Licence Number L8575/2011/1

Licence Holder Independence Long Pty Ltd

Premises Victor Long Nickel Complex
Part of Lot 13 on Plan 48932 (within coordinates
373,122.20 E 6,550,741.97 N, 374,292.19 E
6,550,741.96 N, 374,292.17 E 6,550,541.97 N,
374,648.19 E 6,550,541.97 N, 374,847.28 E
6,550,455.91 N, 374,949.83 E 6,549,577.97 N,
374,310.18 E 6,549,569.96 N, 373,422.20 E
6,550,151.96 N and 373,083.18 E 6,550,151.96 N)
and mining tenements M15/1761, M15/1762 and
M15/17632
COOLGARDIE WA 6442

Date of Amendment 21 August 2018

Map of Landfill Areas

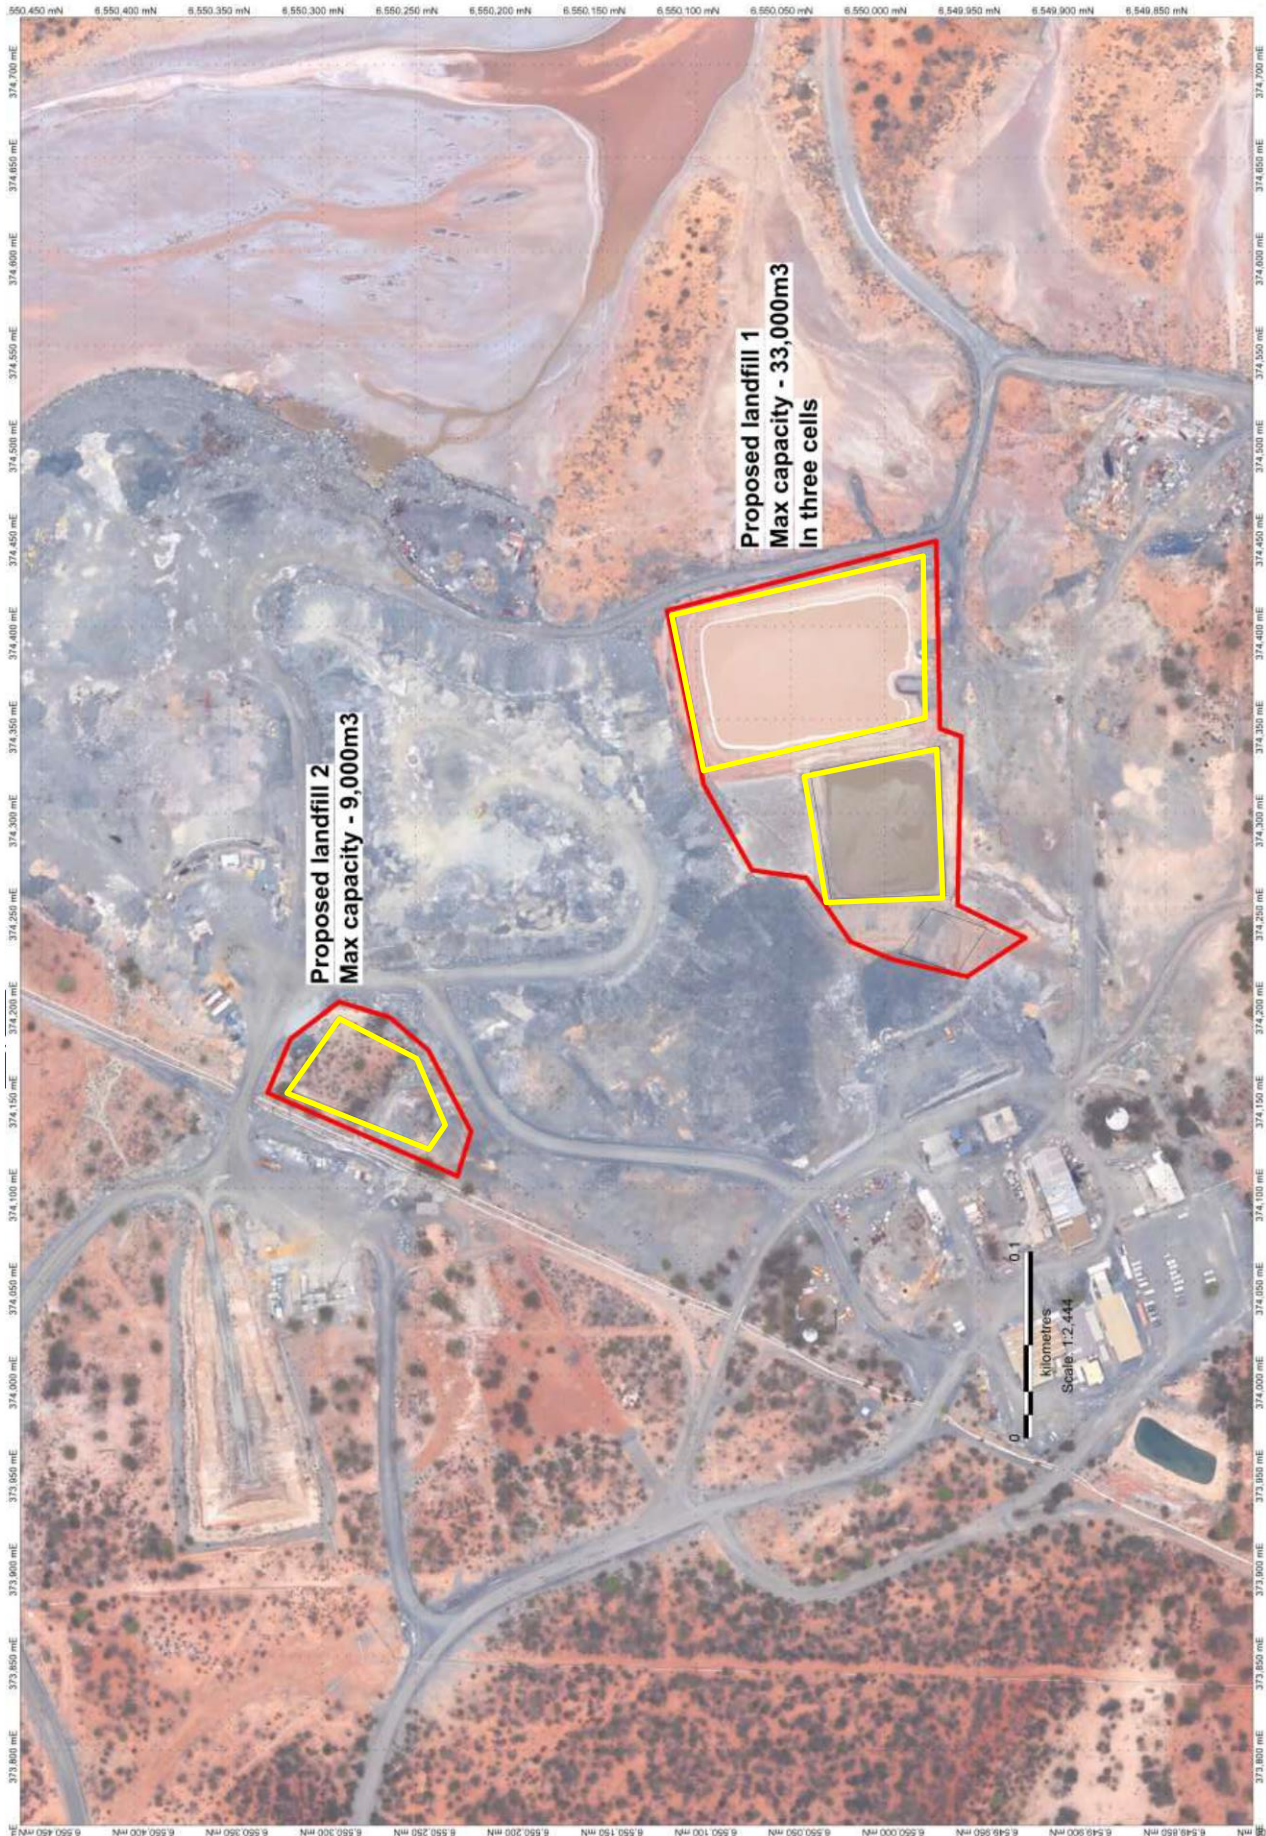
6. Schedule 1 of the Licence is amended by the insertion of the following Map of Landfill Areas:

The location of the landfill areas defined in Tables 1.3.4 and 1.3.6 are shown below in yellow outline.
